## D/DRC Case

1817 Pickens Street

**DESIGN/DEVELOPMENT REVIEW COMMISSION**  
**DESIGN REVIEW DISTRICT**  
**HISTORIC AGENDA**  
**EVALUATION SHEET**  
Case # 1

**NATURE OF REQUEST:** Request Certificate of Design Approval for exterior changes

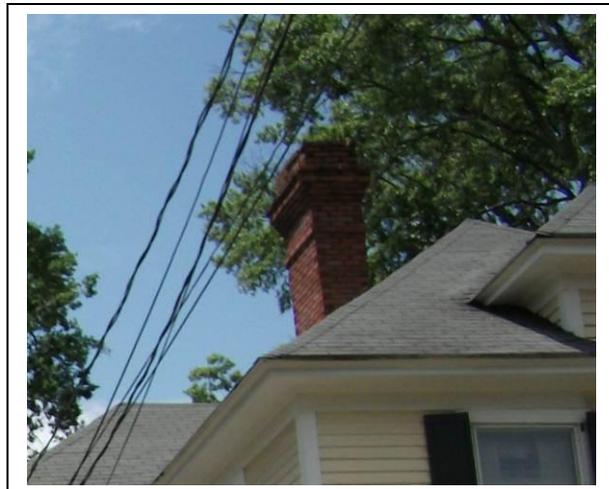
This guideline requires the repair of deteriorated features. The applicant has provided one photograph showing some mortar loss in the top courses of the chimney. Chimneys typically deteriorate from the top down because the soft lime mortar loses its binders over the years from rain water. Mortar has a life span and must be re-applied after several decades; this is a normal maintenance process for historic masonry. The mortar on this chimney was not repaired when it showed signs of deterioration.

The severity of the deterioration of this chimney could not be assessed by staff because it was completely removed by the time staff arrived at the site. The photograph from the applicant and staff's view of the sandy mortar indicates that there were areas of deterioration at the top courses of the chimney due to mortar loss, but there does not seem to be any indication that the bricks themselves were deteriorated or that the mortar loss continued further down than the top few courses. The chimney should have been repaired with new mortar and with re-pointing for deteriorated joints to comply with this guideline.

Staff finds that the removal of the original chimney does not meet Section 17-674(d) of the City Code of Ordinances and recommends the request be denied.

**Above:** 1992 survey photo from city files

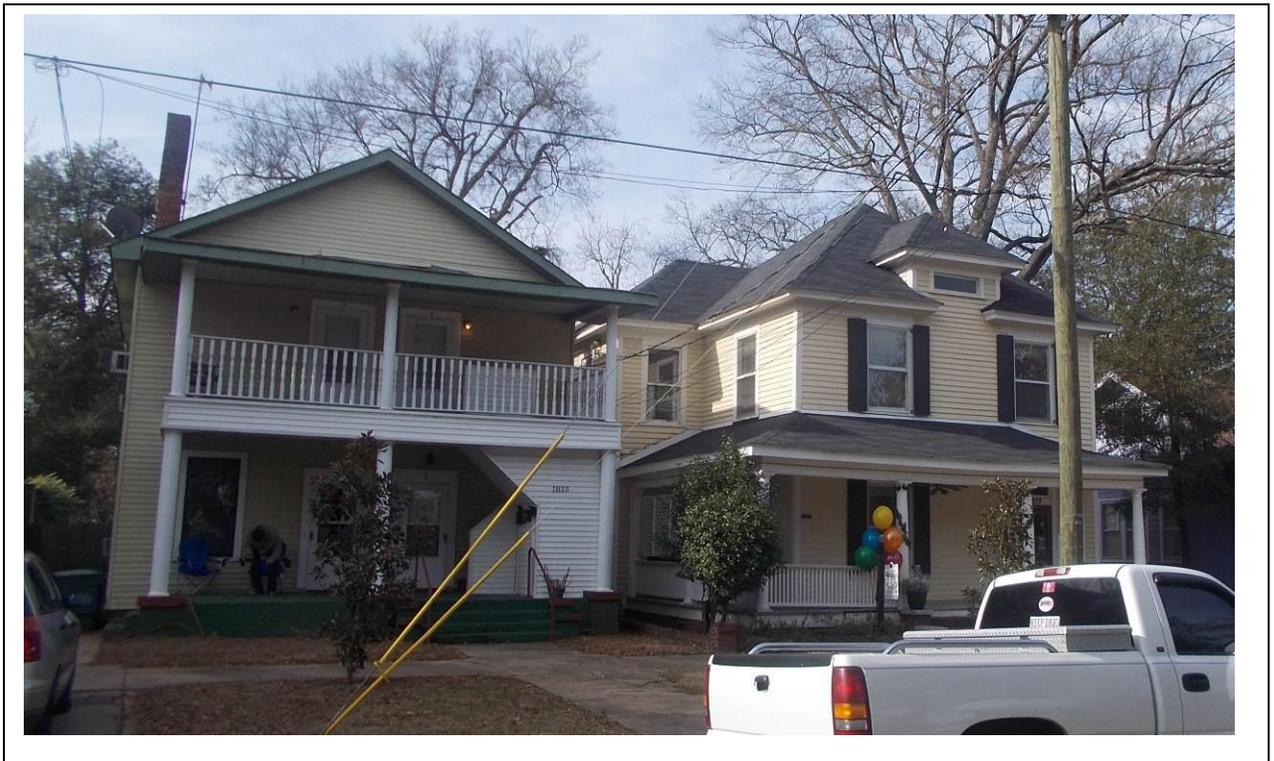
Removing the chimney was an exterior alteration that destroyed historic material that helped characterize the property. This was the only chimney on the roof. Its detailing was consistent with an early twentieth-century chimney type and it was original to the building. It was the most ornate chimney of its neighbors facing Pickens Street. Its removal does not meet this guideline.

Images above by staff show the work conducted on the roof, the mortar and brick dust and broken brick resulting from the drop of materials from the roof onto a concrete sidewalk, and the building as it looks today.

Staff recommends that to comply with Section 17-674(d) of the City Code of Ordinances that the chimney be rebuilt exactly, within a period of 120 days.
